NOTICE OF A TYPE II DECISION ON A PROPOSAL IN YOUR NEIGHBORHOOD

CASE FILE NUMBER: LU 08-141883 DZ

The applicant requests design review approval for the construction of a series of retaining walls surrounding an existing surface parking lot. The walls will be constructed of a mix of dry stacked stone and mortared stone. The new walls replace an existing stone wall originally constructed in 1865. This wall has been partially demolished due to safety concerns following the wall's recent failure. Due to the uneven nature of the existing stone, its reuse in the project is limited to a wall containing an historic plaque, as well as throughout the new walls and at

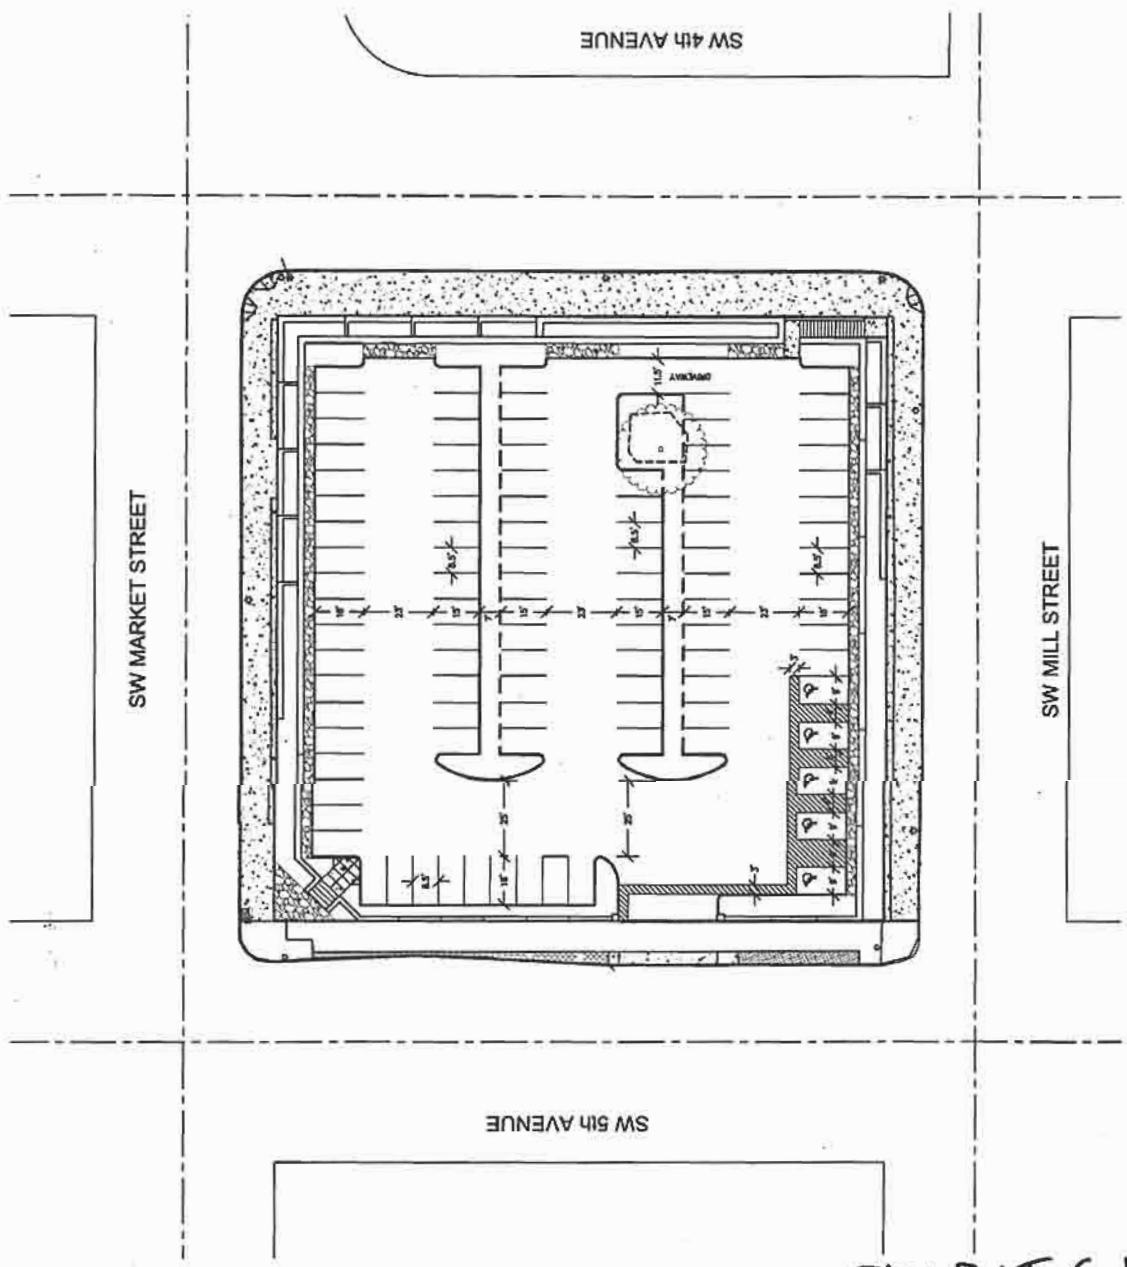
In association with the existing driveway along SW 5th Avenue, Portland Transportation has identified a potential conflict resulting from the proposed parking lot circulation plan. As

shown, there are no end aisles proposed towards the eastern end of the parking lot. If a potential patron enters the southern-most aisle in the parking lot and is unable to find an available parking stall, there is insufficient area to maneuver and turn-around in order to search for another spot to park. This patron would be forced to back out of the aisle, potential creating conflicts for other patrons attempting to enter to lot, which potentially could impact the Street Car line (especially) along the east side of SW 5th Avenue. To avoid these potential conflicts, Portland Transportation staff will require the applicant to provide an end aisle *at least* between the southern-most aisle and the middle aisle.

Portland Transportation has no objections to the proposed Design Review, subject to the applicant providing an end aisle *at least* between the southern-most aisle and the middle aisle to provide better circulation than proposed and to avoid potential conflicts internal and external to the parking lot. The applicant shall change the submitted plan to reflect the end aisle(s) as part of the permit process.”
